MONTGOMERY COUNTY HISTORIC PRESERVATION COMMISSION
STAFF REPORT

Address:	8 E. Irving St., Chevy Chase	Meeting Date:	6/22/2022
Resource:	Contributing Resource Chevy Chase Village Historic District	Report Date:	6/15/2022
Applicant:	Dana Beyer	Public Notice:	6/8/2022
Review:	HAWP	Tax Credit:	n/a
Case Number:	988112	Staff:	Dan Bruechert
Proposal:	After the Fact Deck and Pergola Construction

Existing Deck with new tall posts	
SCALE: 3/8"=1ft	APPROVED BY:
DATE: 4-5-2022	REVISED
DRAWING NUMBER	
01

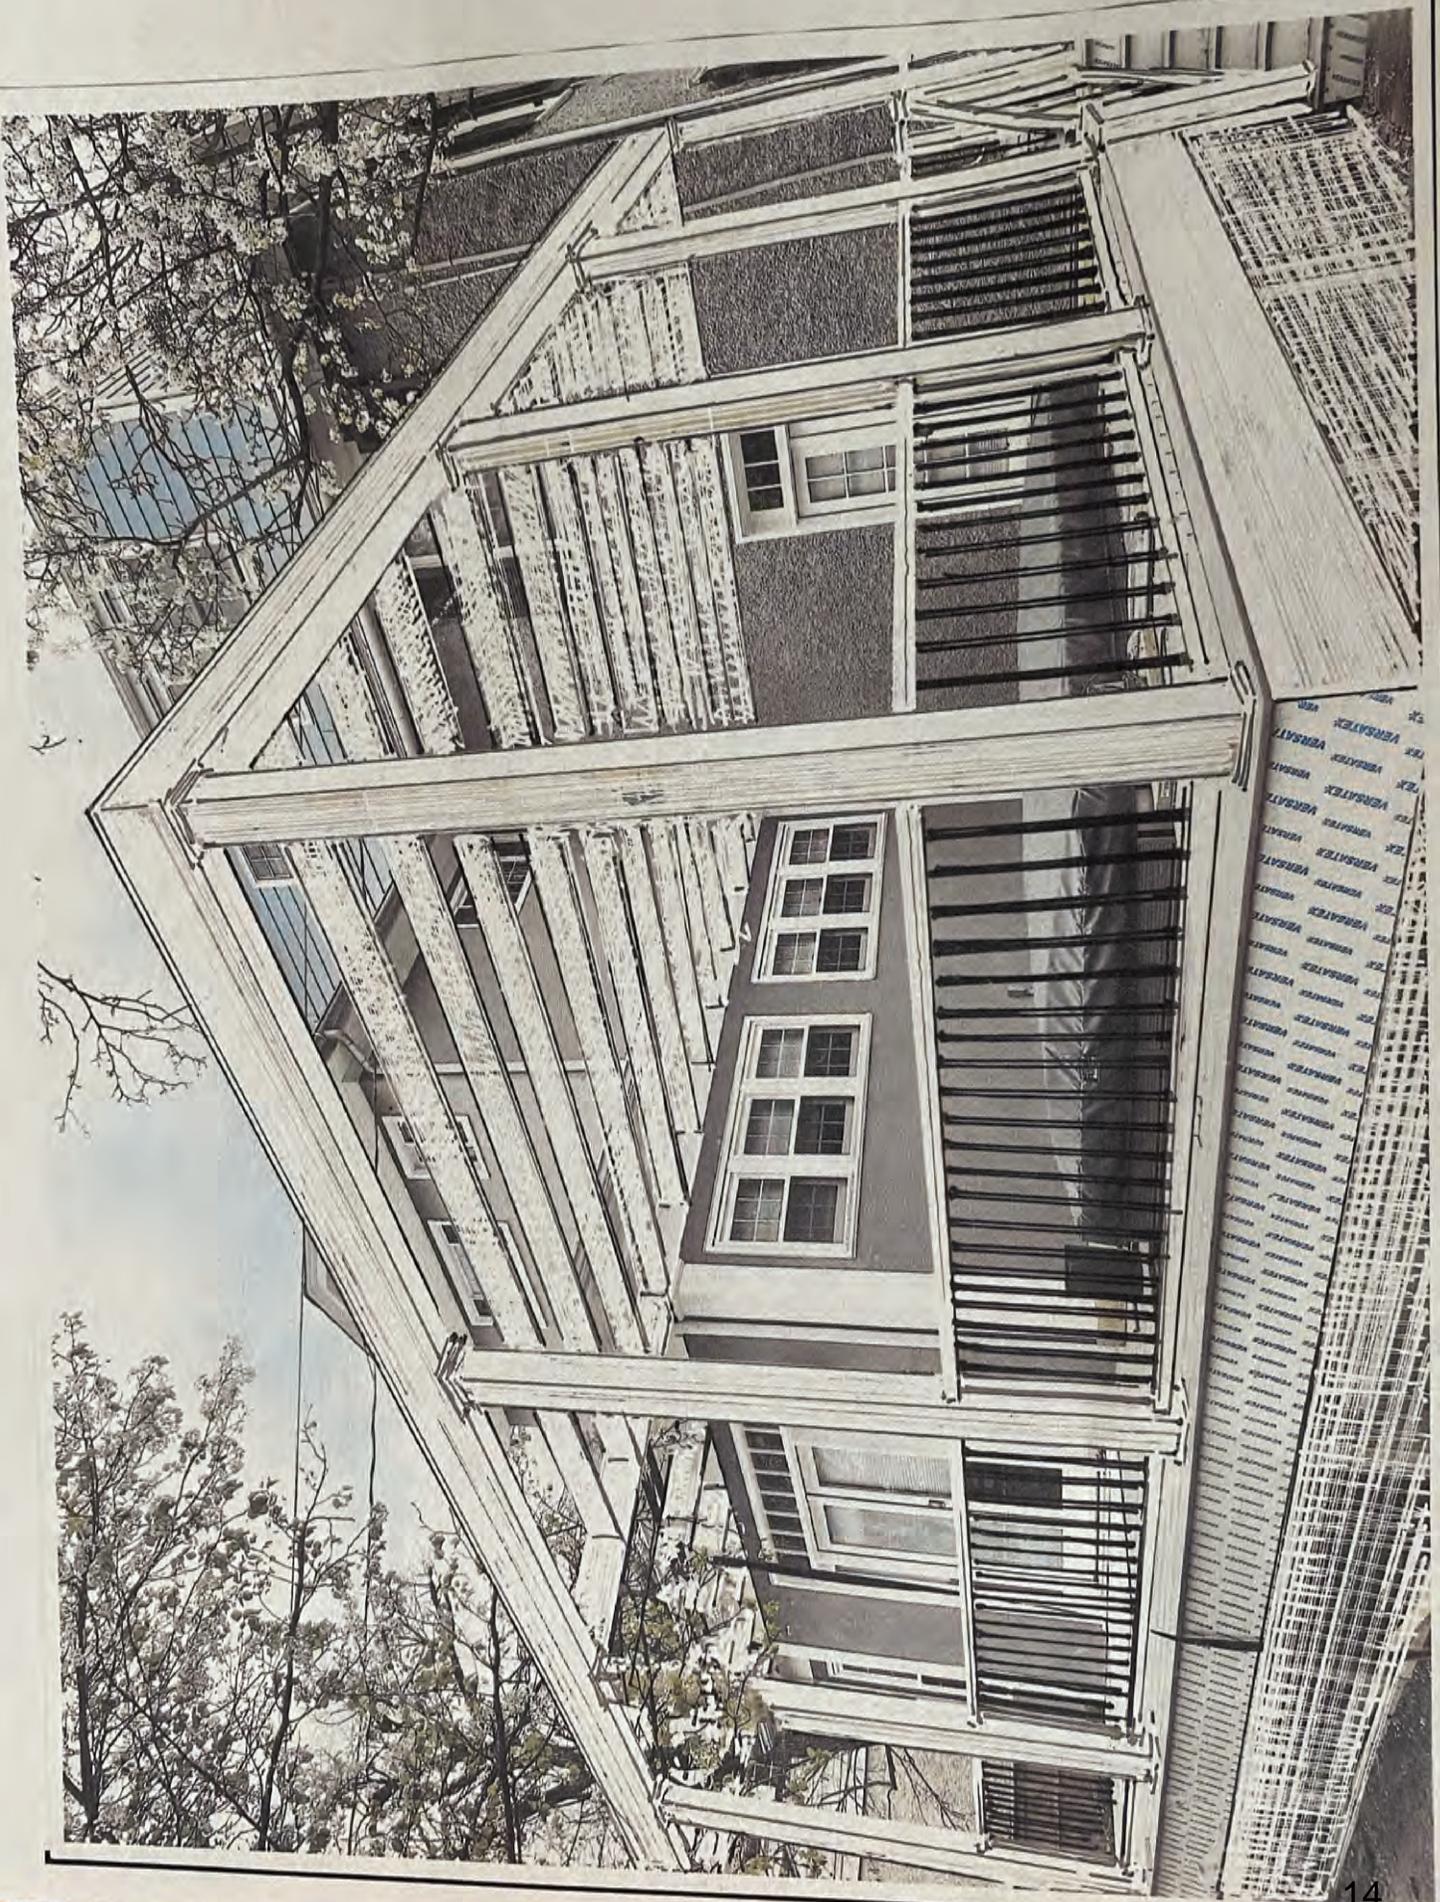
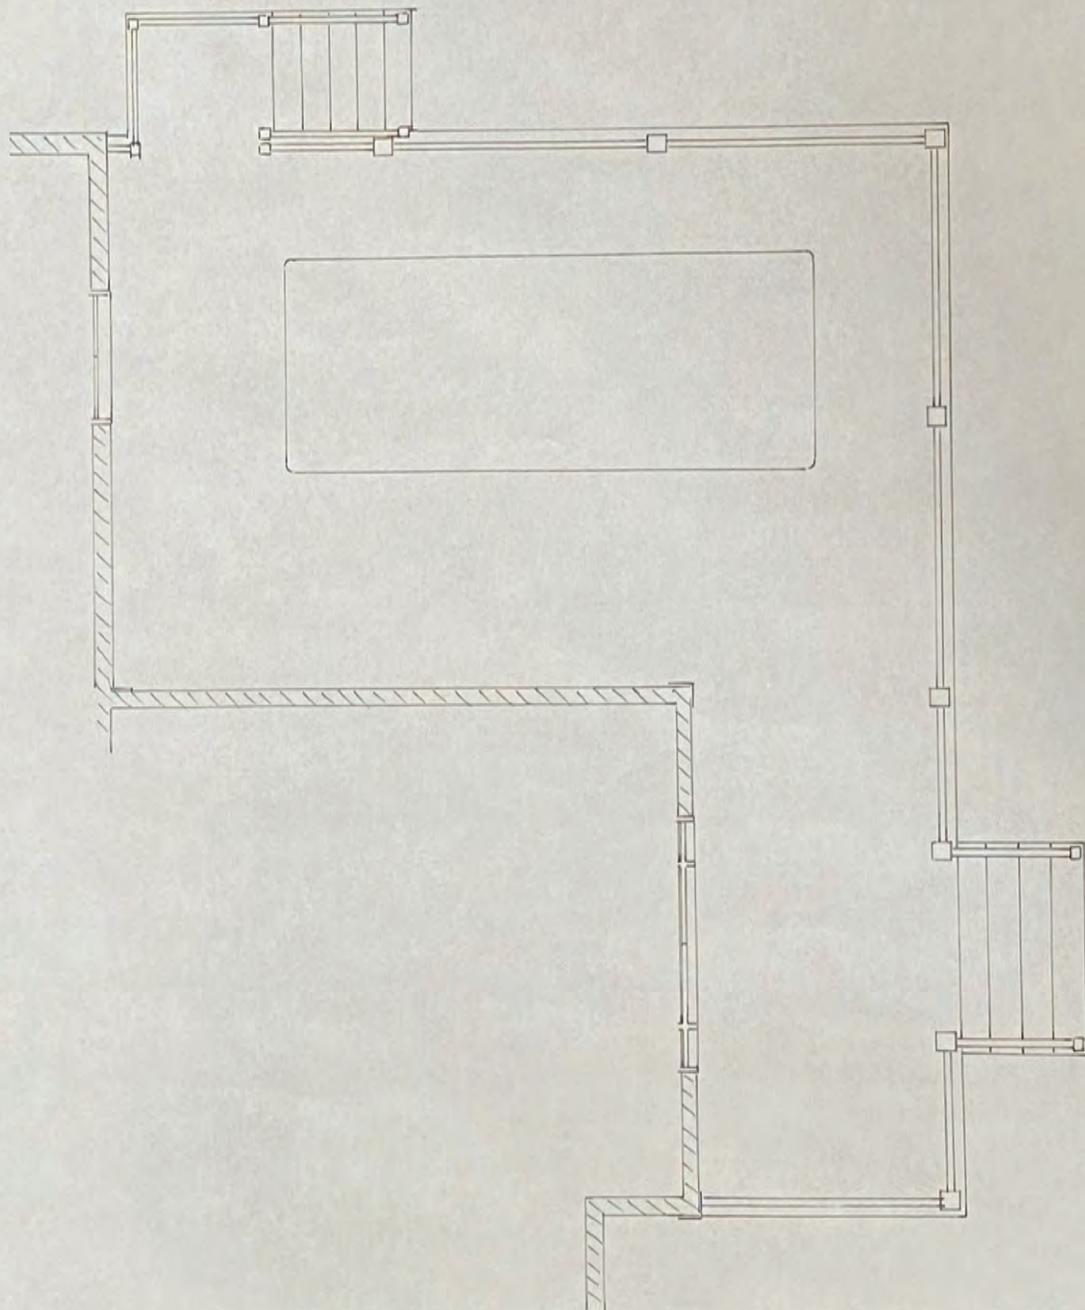
The applicant proposes to install a new deck, in slightly larger dimensions out of wood with composite decking and stairs. The proposed deck measures approximately 35' × 26' (thirty-five feet by twenty-six feet) using Trex composite decking with wood supports. The proposed railing has Trex posts and top and bottom rails, with aluminum balusters. The deck includes a hot tub installed at decking level. The applicant also proposes to construct a pergola over the deck. The porch posts will be wrapped in Trex and extend to 8' 9" (eight feet, nine inches) to support the pergola. Finally, the applicant proposes to install cloth privacy screens on the side of the pergola.

Staff finds the proposed deck will not be at all visible from the public right-of-way, because it is hidden by the existing privacy fence. Staff believes that the *Guideline* for porches was written with mid-block houses in mind. The rear of those properties would not be visible from the right-of-way, because they would be obscured by the mass of the historic house. Part of the subject property is obscured by a solid privacy fence that runs the entire length of the property along Brookeville Rd. Theoretically, this fence could be removed at a future date, but Staff finds that is unlikely because of the high amount of traffic along Brookeville Rd. and because there is a sidewalk only on the eastern side of the street, virtually all of the houses on the west side of Brookeville Rd. have maximum height privacy fences. Staff does not

expect this condition to change. Because the fence blocks the deck location, the *Design Guidelines*, therefore, require the new deck to be reviewed under lenient scrutiny and further state that alterations that are not visible from the right-of-way are subject to a “very lenient review” and “most changes should be approved as a matter of course.” Staff finds the size of the proposed deck is not out of proportion with the house or surrounding district and is compatibly designed. Staff is generally opposed to Trex composite decking in historic districts because it does not have the same visual and material qualities as wood. However, the *Design Guidelines* state lenient scrutiny, “should allow for a very liberal interpretation of preservation rules.” Staff finds that under the lenient review required by the *Design Guidelines*, the HPC should approve the proposed deck, railing, and stairs.

NEW BEAMS AND RAFTERS

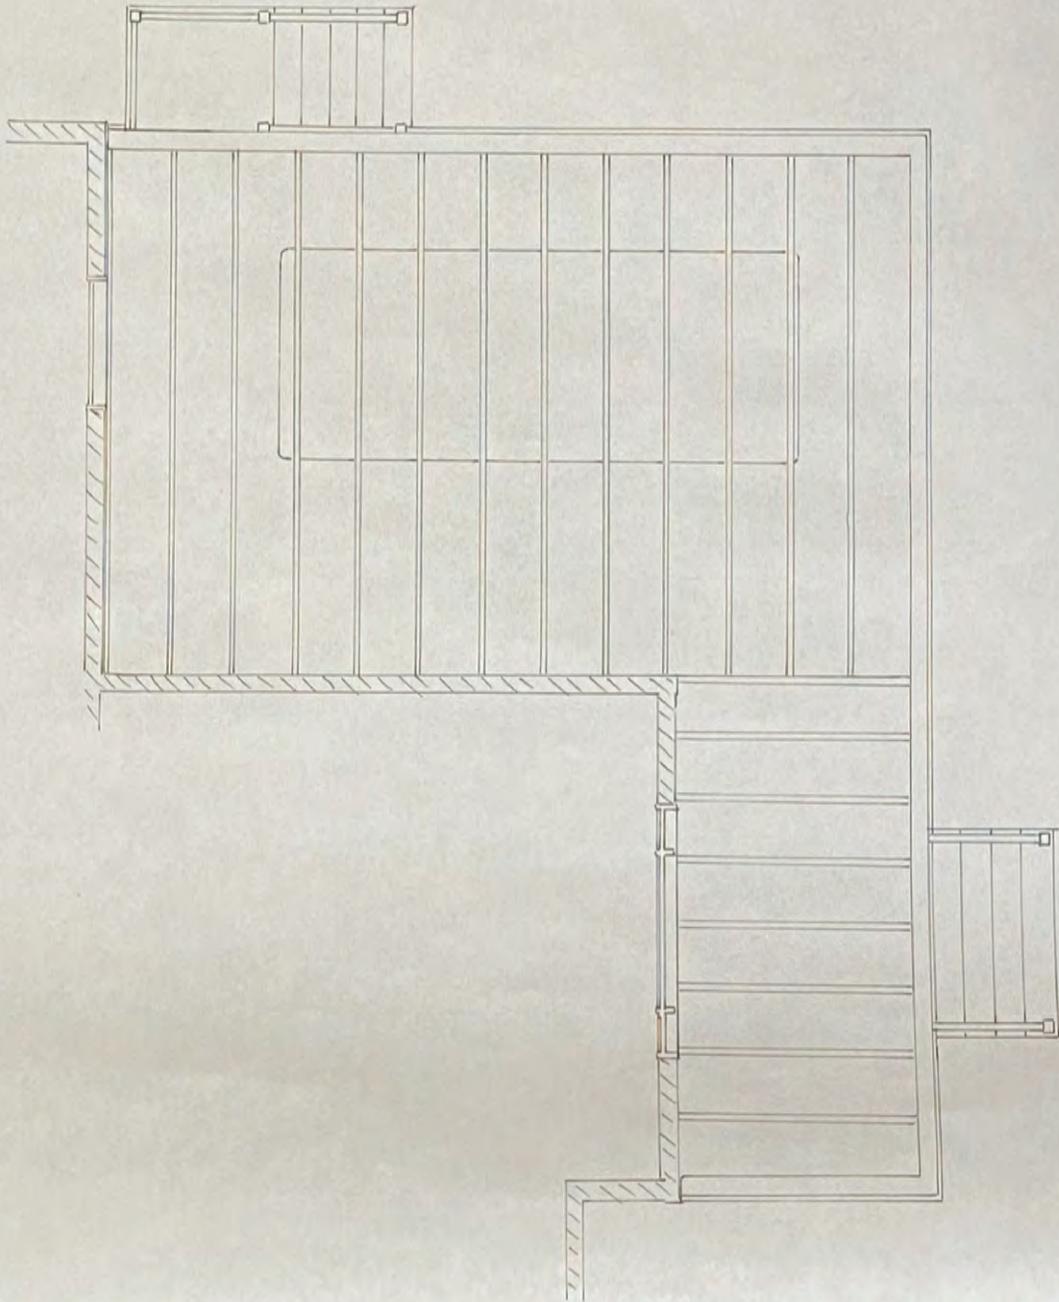
The next item up for consideration is the proposed pergola. The pergola covers the entirety of the rear porch and will be framed in wood, with the posts covered by Trex sleeves, to match the trim on the house addition and the porch. The pergola slats will be wood. The pergola slats only connect to the non-historic addition and will not impact any historic fabric. The applicant also proposes to install fabric roll-up screens for additional privacy from the public right-of-way.

Staff finds the proposed pergola will not have a substantial impact on the scale or massing of the subject property because it is a largely transparent feature. Reviewing the pergola under moderate scrutiny, Staff finds that the composite wrap on the pergola posts should be considered a “compatible new material” under the *Design Guidelines* and notes the material will match the dimensions and details of the non-historic rear addition. Staff finds the wood slats are appropriately detailed. Staff also considered the size and massing of the proposed pergola as if it were a screened-in porch and found that the size would not overwhelm the existing historic house.

TANG Exterior Patio Deck Porch Pergola Roller Shade Roll up Shade Blinds for Balcony Backyard Light Filtering Block 90% UV Rays 8' W x 6' L Beige

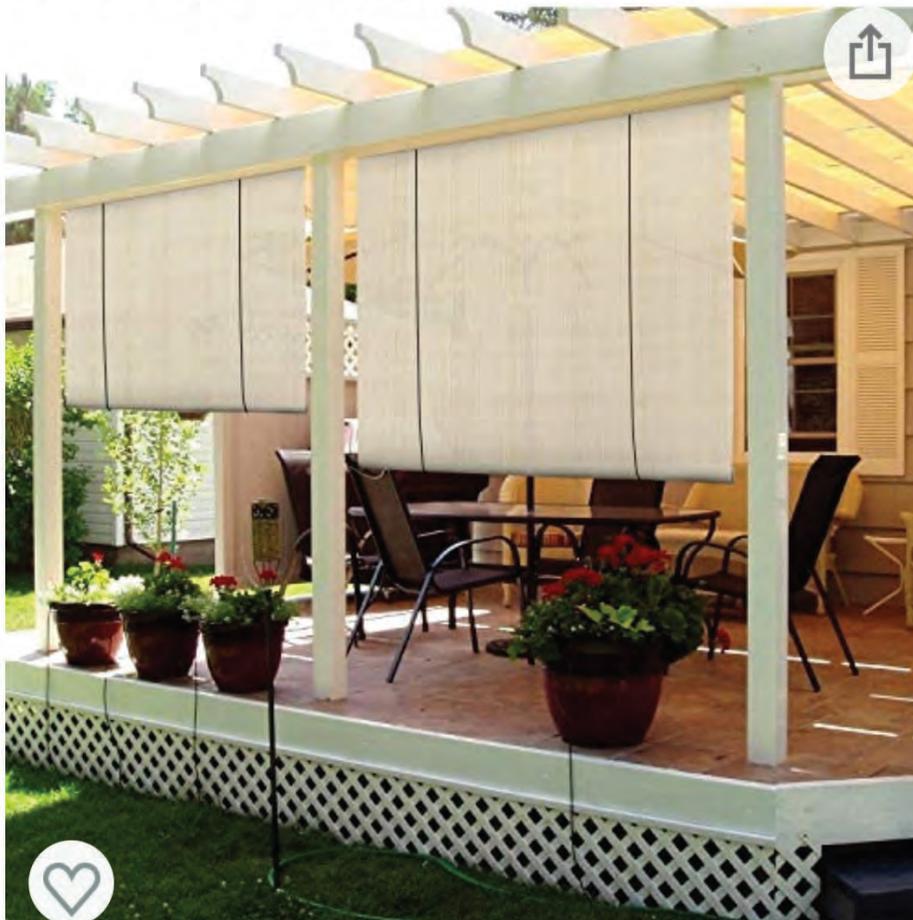
Staff recognizes several factors that make a privacy screen desirable at the subject property including the house’s proximity to several very busy streets including Brookeville Rd. and Western Ave. Staff finds the cloth privacy screen will not detract from the appearance of the existing proposed pergola and deck. Staff also notes that the proposed privacy screen can roll up when not in use so that it will not be visible from the right-of-way. Staff recommends the HPC approve the pergola and proposed screen under the *Design Guidelines*, 24A-8(d), and Standards 9 and 10.
